**From:** Hoban, John: PC-BlgCtrl [john.hoban@rbkc.gov.uk]  
**Sent:** 08/01/2014 15:20:13  
**To:** Bruce Sounes [bruce@studioe.co.uk]  
**CC:** Hanson, Paul: PC-BlgCtrl [paul.hanson@rbkc.gov.uk]  
**Subject:** RE: Grenfell Tower, Grenfell Road, Refurbishment - Fire Strategy P2

Grenfell Tower, Grenfell Road, London. W11

The Building Regulations 2010 [as amended]  
Grenfell Tower, Grenfell Road. London. W11.

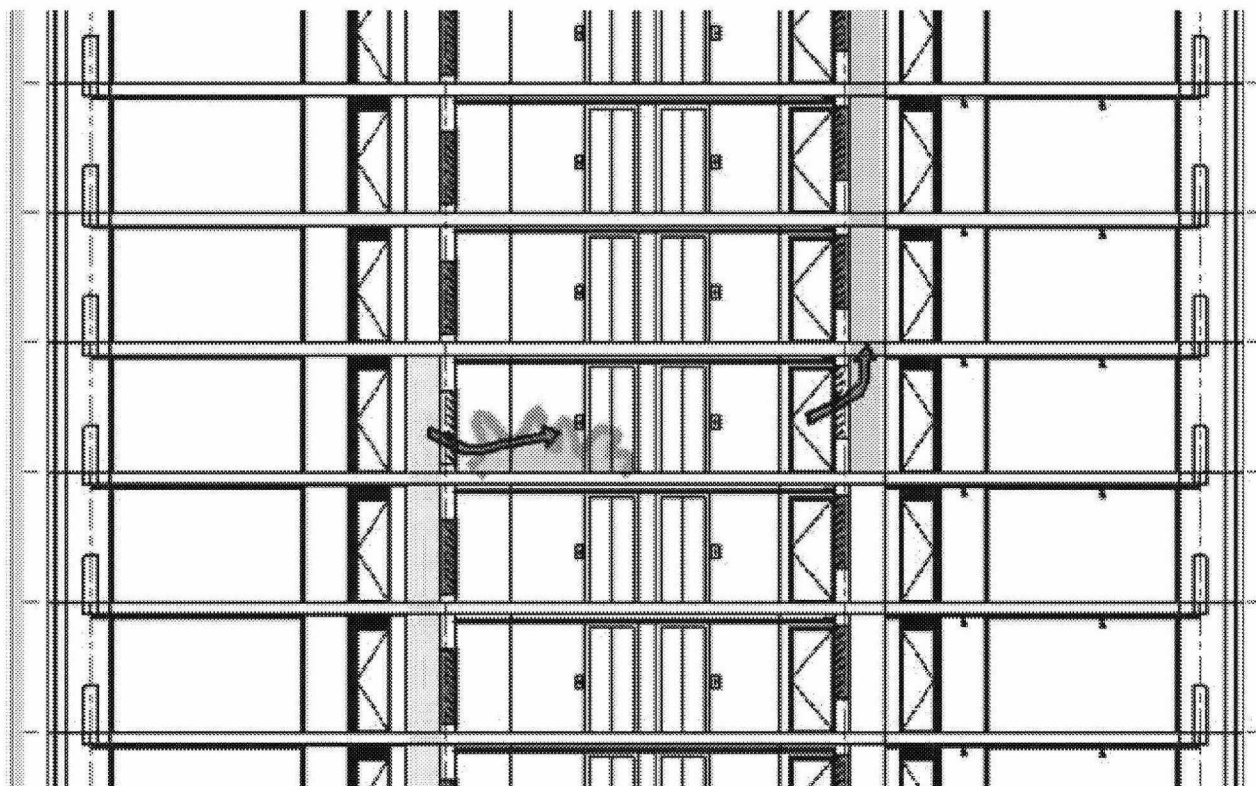
1. "...is designed .. as a natural ventilation system..." (line 2) is followed by "a mechanical supply and extract system which does not rely on natural ventilation" (Smoke Control, second para). His initial response is that this reads like we are omitting a compliant natural vent shaft. We could just leave the 'compliant' system as it is at present, but we (and Exova) think it would be better to provide a more predictable system with mechanical supply and extract as the default mode, all as described in the 'Proposed System' part of our report.
2. Some diagrams would be useful. I have attached our schematic drawing and Studio E have provided the visual representation below.

3. Principle of dual use of duct for vent and smoke okay – but not clear from document and would like some detail as to how this will be achieved.

The smoke controls and the temperature controls would all be part of the same control system controlling the dampers and the supply and extract fans.

Under normal conditions, all the dampers would be open and the system would operate as a natural ventilation system. Temperature sensors would be located on 'typical' (say 5 No.) lobbies. If the temperature in any of these areas exceeded a pre-set comfort level, then the supply and extract fans would operate to try

In the event of smoke being detected within any lift lobby served by the smoke control system, the fresh air and smoke dampers serving that particular lobby would remain open and the supply and extract fans would operate. The fresh air and smoke dampers on all other levels would be closed. The system would be set up such that it was 'fail-safe' with priority always being given to the fire safety operation.
